**Attachment 1**  
**DFG and CAL FIRE Comments and Recommended Changes**  
**Threatened or Impaired Watershed Rules, 2009**  
**June 18, 2009**

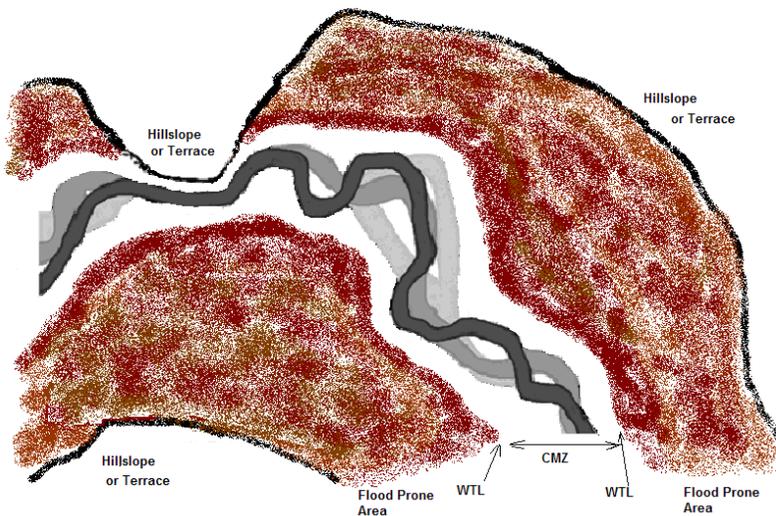
The Departments support adoption of a definition for channel migration zone (CMZ) and recommend replacing the proposed definition and Figure 1 with the modified definition and Figure 1 below in order to clarify and correct the relationship of the 80-year design life to the CMZ delineation. The replacement Figure 1 eliminates confusing dashed lines at the edge of the channel margins to better represent the zone within which channels may migrate.

Channel Migration Zone means the area where the main channel of a watercourse can reasonably be expected to shift position on its floodplain laterally through avulsion or lateral erosion during the period of time required to grow forest trees from the surrounding area to a mature size, except as modified by a permanent levee or dike. The result may be the loss of beneficial functions of the riparian zone or riparian habitat (see Figure 1).
